TECHNICAL BULLETIN

Brava Cedar Shake and Slate Roof System Update
Published March 08, 2024

BRAVA CEDAR SHAKE & SLATE STARTER REDESIGN

REDESIGN DETAILS

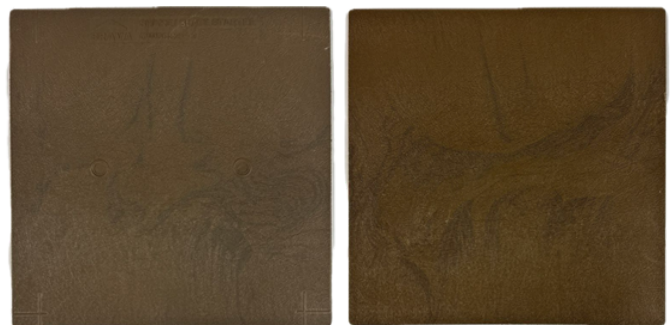
The updated Brava Shake and Slate Starter is compression molded, tapered slightly from top to bottom, and solid throughout. It can be cut at valleys, rakes, hips, and other details without exposing structural ribbing. The Solid Starter is textured on every surface to allow versatility during installation depending on what section of the starter may be visible.

PREVIOUS STARTER – 12" X 12"
TEXTURE ON FRONT EDGE/STRUCTURAL RIBBING BACK

NEW STARTER – 12" X 12"
TEXTURED ON EVERY SURFACE/SOLID THROUGHOUT

FOR A CONSISTENT APPEARANCE, THE TWO VERSIONS SHOULD NOT BE INSTALLED TOGETHER.
